2018 CONSTRUCTION SEASON AS-BUILT REPORT TAILINGS STORAGE FACILITY MEADOWBANK GOLD PROJECT, NUNAVUT

1897439-1578-R-Rev0

November 2018

Design changes and field adjustments occurred during the 2018 construction season to adapt the initial design to the field conditions encountered during construction. These design changes and adjustments were implemented by the Designer (Golder) in partnership with AEM and were documented in the present report, or in technical memoranda. Per AEM's request, one design change memorandum was issued this year, while the other changes and adjustments are documented in Section 5.0 of this report. Relevant design changes memoranda from past construction years were applied to the 2018 construction season. Table 9, Table 10 and Table 11 list the technical memoranda that discuss field adaptation or modification from the initial Technical Specifications and Drawings relevant to the 2018 Construction Season listed in chronological order. The technical memoranda issued during the 2018 construction season can be found in Appendix B. For the other design change technical memoranda, refer to past as-built reports.

NORTH CELL AS BUILT DIKE CONSTRUCTION CONTRACT # 11-505

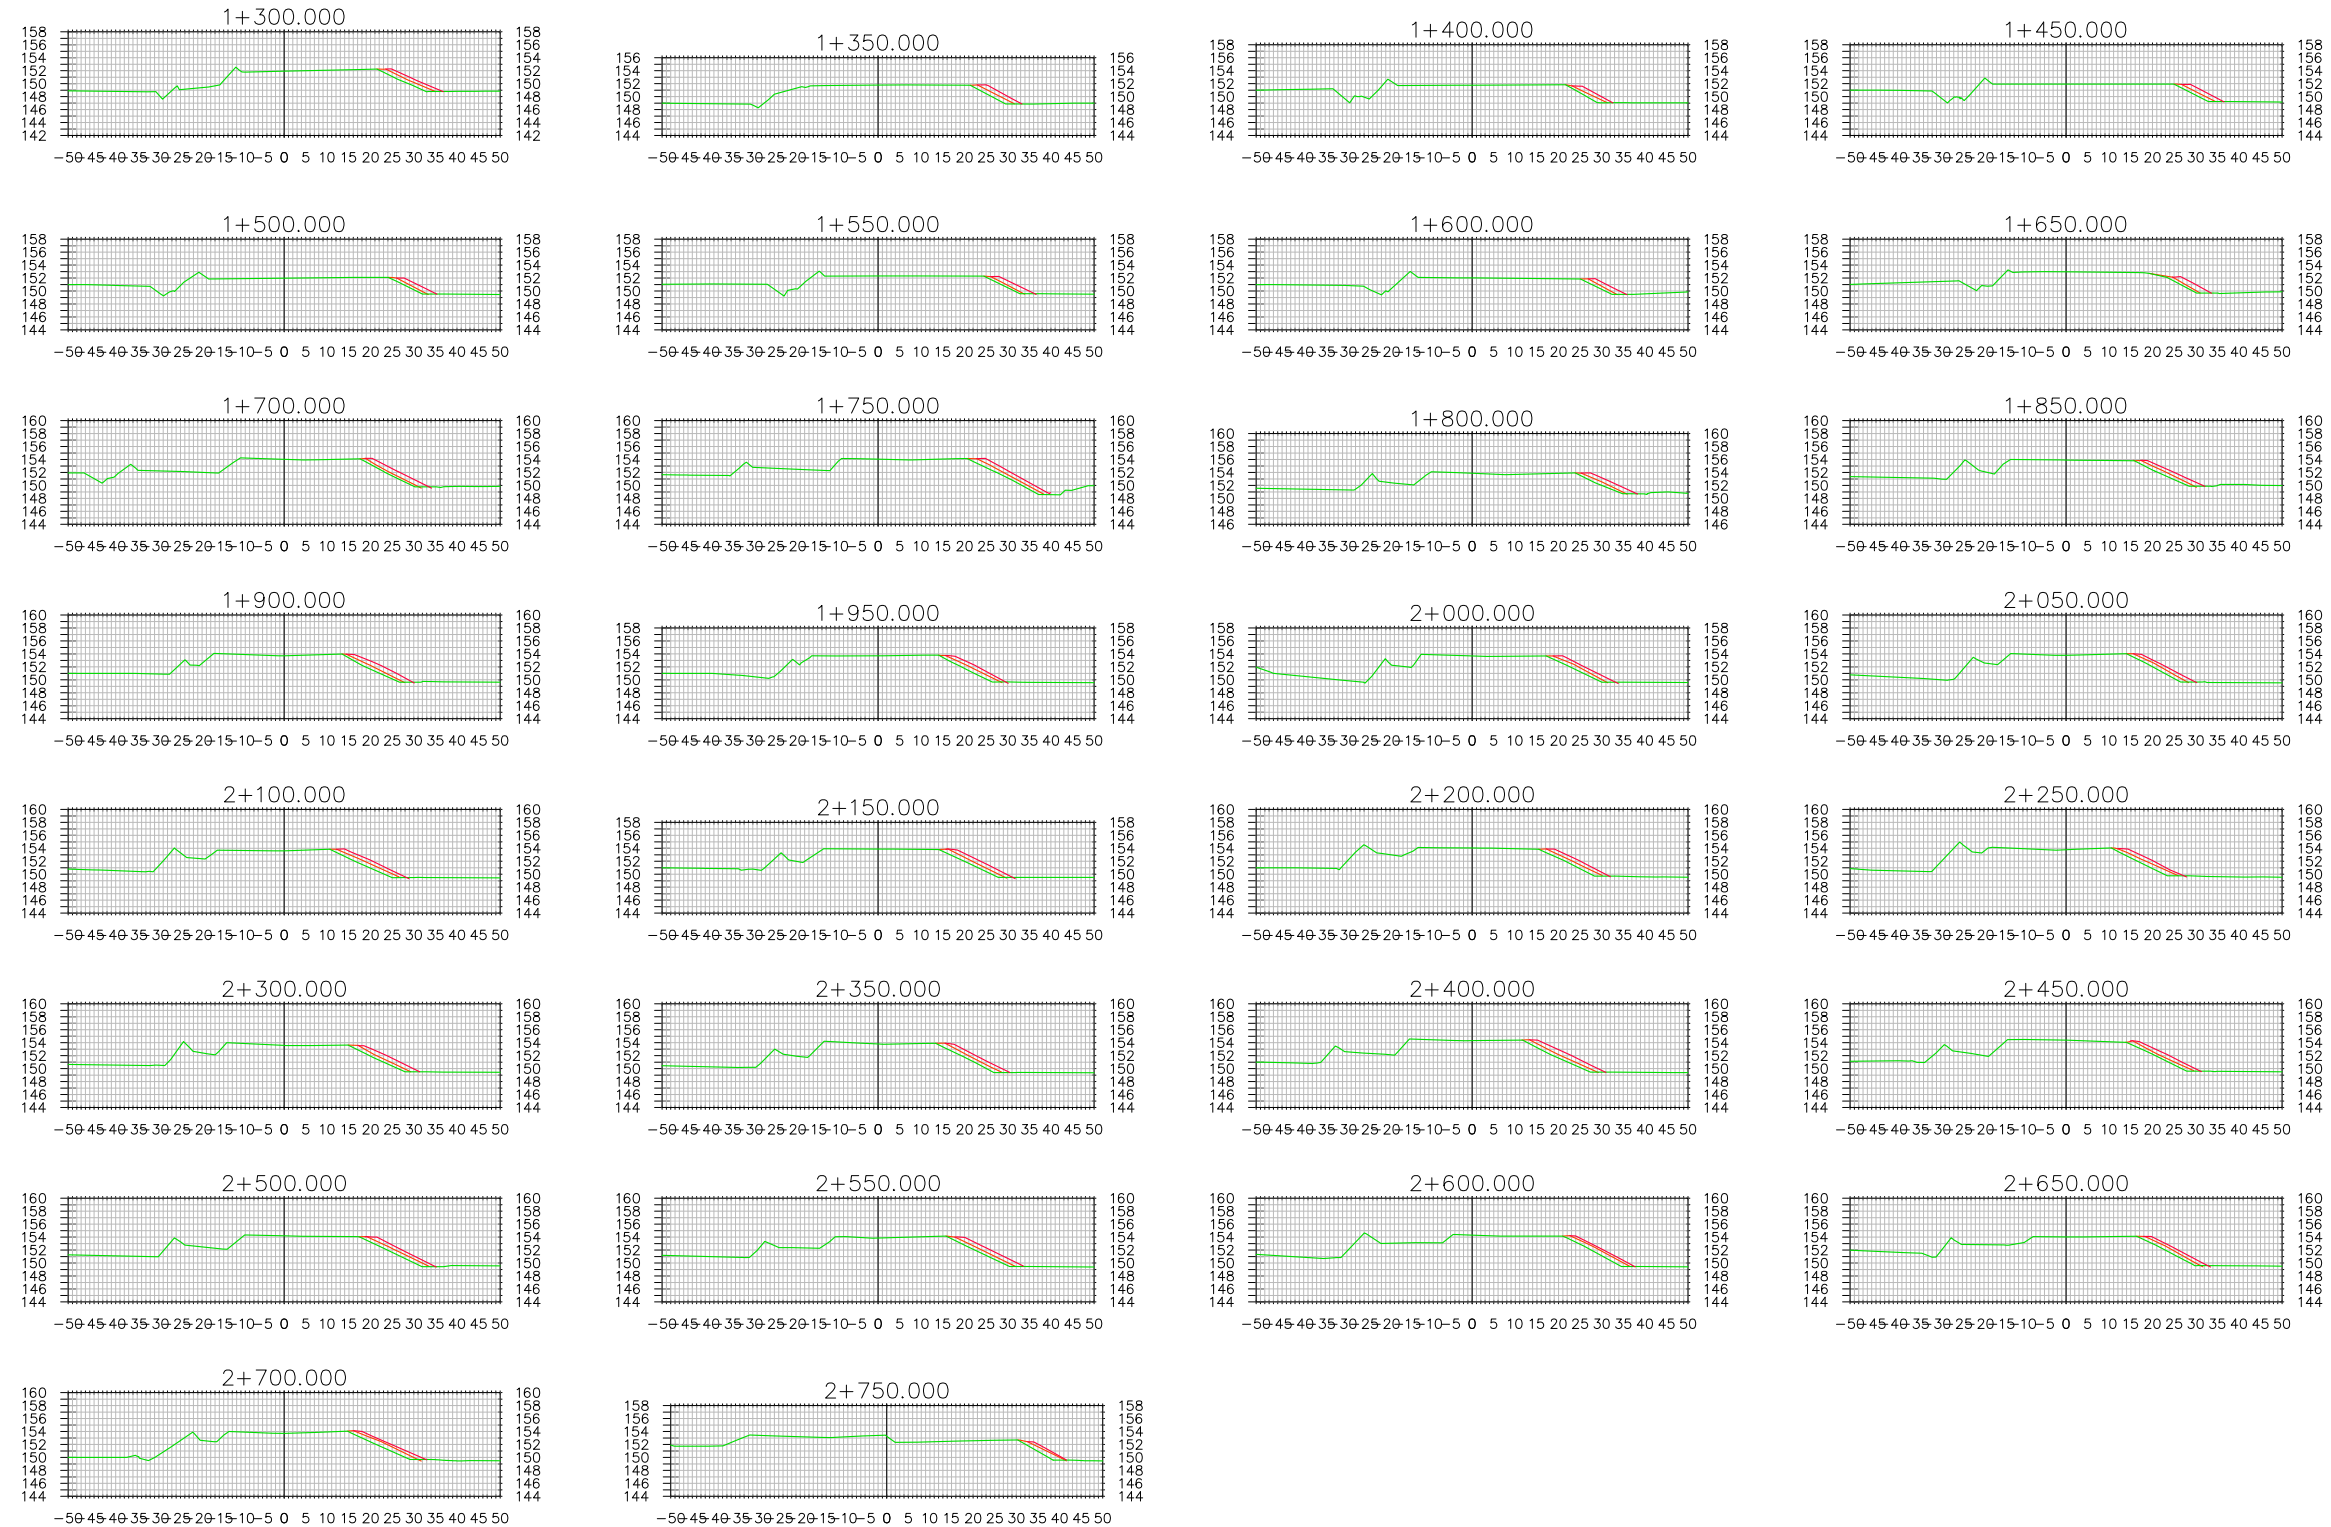
Following AEM's decision with the agreement of the Designer, the North Cell Internal structure was built on the upstream end of the North Cell capping and on the existing tailings. As a result, the Internal Structure is offset towards the centre of the North Cell as opposed to the initial plans. The upstream toe of the rockfill capping was mapped to perform a field fitting of the design and a new centerline was drawn. In this updated configuration, the filters extend down to the tailings at their base. The southwestern portion of the structure, built on tailings, was realigned in order to avoid the cyanide burning area. The structure was also shortened compared to the initial plans, as deposition plans indicated that a shorter length was required (see as-built drawings in Appendix A).

Figure 1: Proposed layout of the thermistors (symbolized by numbered black squares) around deposition points

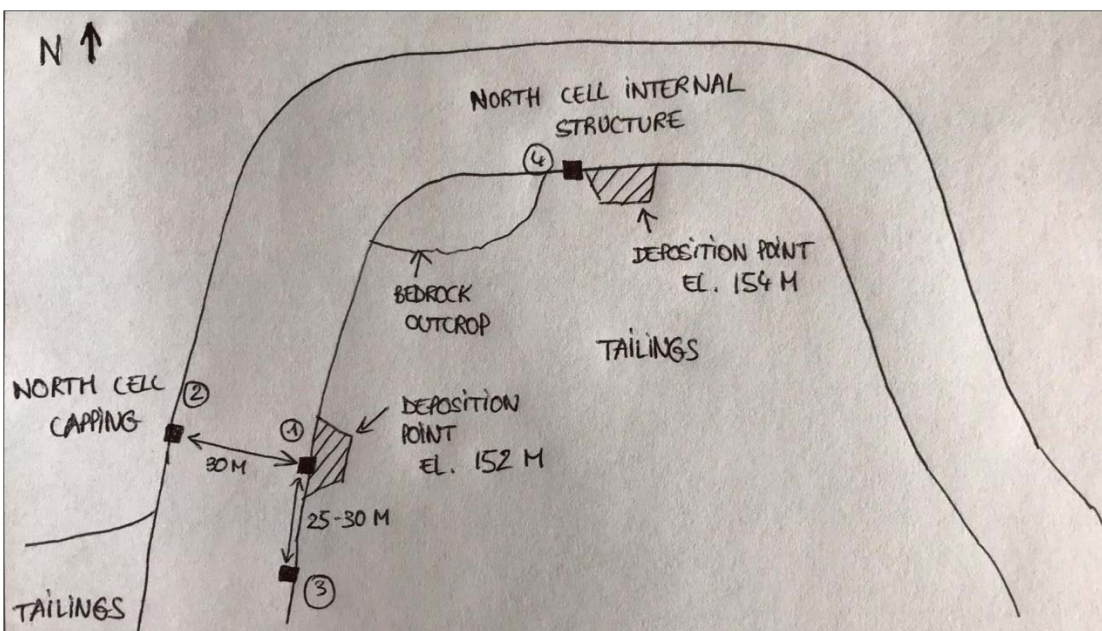
The thermistors should be installed at and around a deposition point, in order to monitor the behaviour of the foundation and structure with regards to the deposition.

- One instrument should be installed as close to the deposition point as safely manageable, on the upstream crest (number 1 on Figure 1 below);
- A second instrument should be installed on the downstream crest, across from the deposition point (number 2 on Figure 1 below);
- A third instrument should be installed on the upstream crest 25-30 m away from the first one (number 3 on Figure 1 below).

by AEM and agreed upon by Golder to install 3 instruments on the deposition point located in this section, with the above-mentioned configuration to monitor the tailings response. A fourth thermistor was installed near the deposition point located in the northern part of the structure (number 4 on Figure 1).

Figure 2: Schematic cross-section of a thermistor showing the required spacing around the rockfill-tailings interface

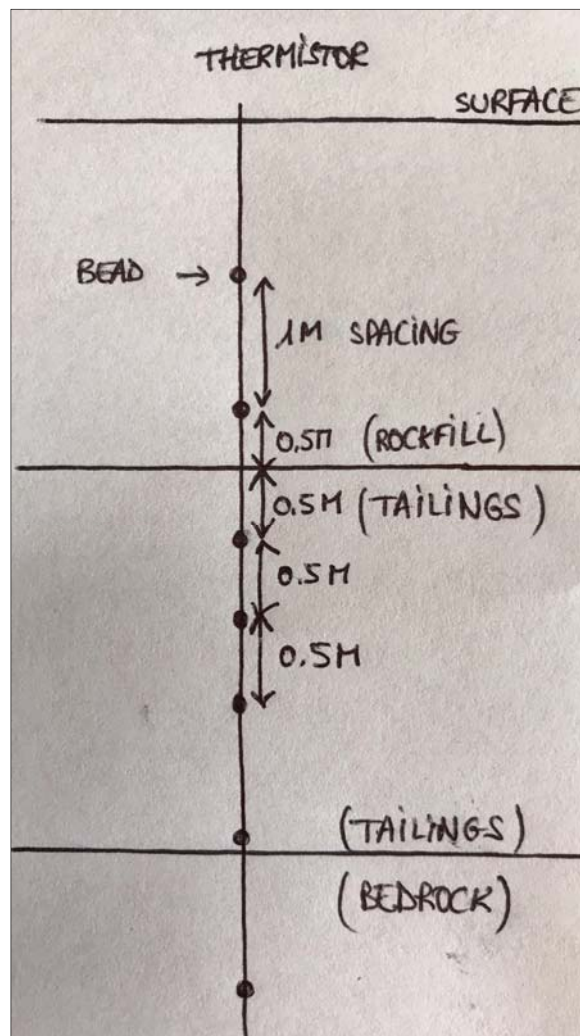
The thermistors should have at least one node at the base of the rockfill, one at the top of the foundation, and extending at least 5 m through the foundation but preferably reaching the bedrock.

The thermistor node locations must be adjusted along the PVC to focus on the area from the base of the rockfill layer to a few metres under the tailings surface. Nodes are to be located within the rockfill layer and one of them 500 mm from the base of the layer. Within the tailings, a few nodes are to be placed every 500 mm from the top of the tailings surface. At least one bead should be installed within the bedrock. Figure 2 below provides an illustration of the required spacing around the rockfill-tailings interface.
